Amendments to the Drawings:

Appl. No.: 09/998,676
Amdt. Dated: October 31, 2005

Attorney Docket: NA01-002
Reply to Office action of Sept. 26, 2005

FIG. 4

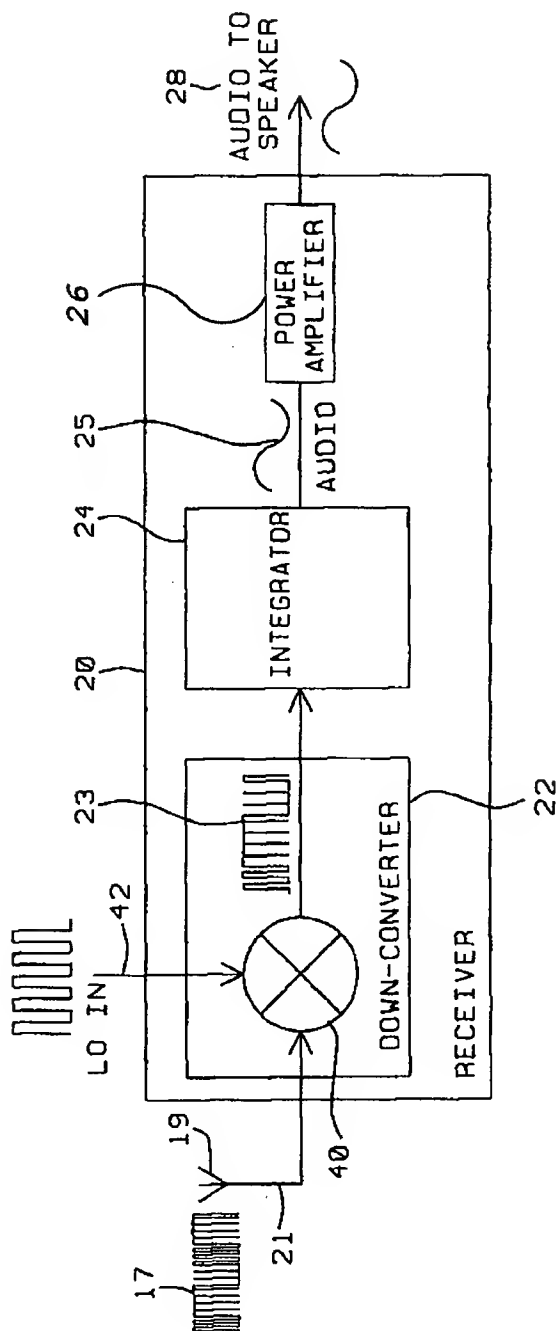
The attached sheet of drawings includes changes to Fig. 4. This sheet, which includes Fig. 4, replaces the original sheet including Fig. 4. In Fig. 4, the previously omitted reference character **26** of the element "**POWER AMPLIFIER**"

20 Fig. 4 has been modified with the changes marked in red on the attached drawings to add the previously omitted reference character **26** of the element

"POWER AMPLIFIER". Approval by Examiner Pham of these changes is requested. No new matter has been added.
